**Re: Response to Review Comments
West Bay Yards Shoreline Restoration
Olympia, Washington
Sage Project No. 033001**

The Washington State Department of Ecology (Ecology) recently reviewed and commented on the revised *West Bay Yards Draft Shoreline Restoration Design Report* and the *West Bay Yards Portadam Feasibility Assessment*.

Cross Section 1. Reproduced from *Preliminary Geotechnical Engineering Recommendations Technical Memorandum* (Landau 2020).

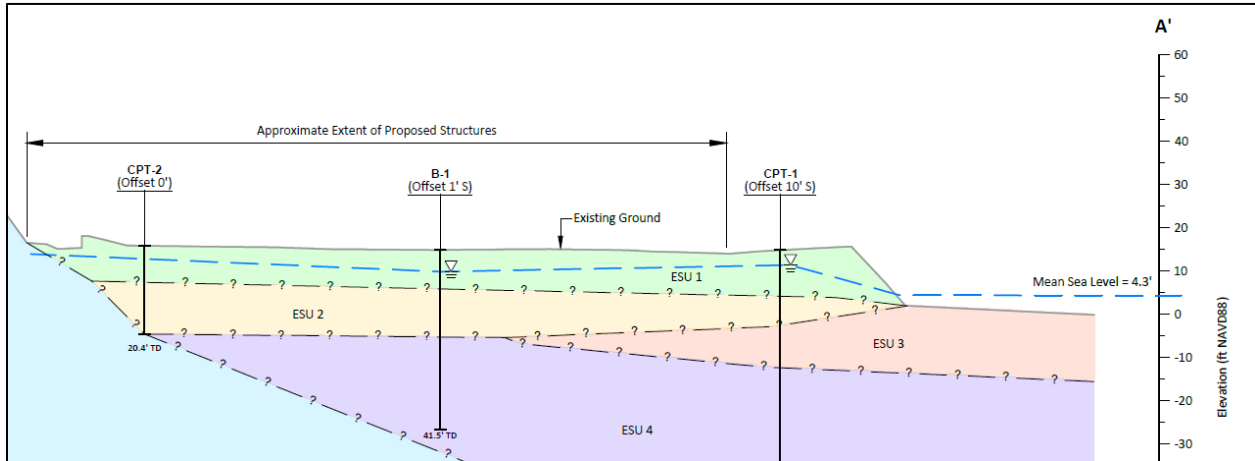
1. If subsurface explorations have not been completed in intertidal areas, how does the consultant know that the conceptual Portadam[®] location is underlain by such poor foundation soils (i.e., soils with a low bearing capacity and low shear strength)?
2. How does the consultant justify the stated risk of obstructions to sheet pile installation when no such obstructions appear in explorations advanced along the shoreline (e.g., test pits TP-2 and TP-3 and cone penetration test soundings CPT-1 and CPT-4)?

ESU 3 extends to the depth indicated by the upland explorations, where it is mantled by roughly 20 feet (ft) of fill (ESUs 1 and 2). The fill was placed over the mud. The bottom of the mud, or the contact between ESUs 3 and 4, is located at an approximate elevation of -15 ft, as shown on Cross Section 1. Sage stands by the engineering judgment used to develop the cross section.

Regarding the thickness of the mud, Sage is confident that glacial geology in the project area dips toward the center of West Bay. Based on its experience with Budd Inlet and East Bay and a review of vast data collected by the Port of Olympia for environmental projects, Sage interprets the mud to be 15 to 40 ft thick.
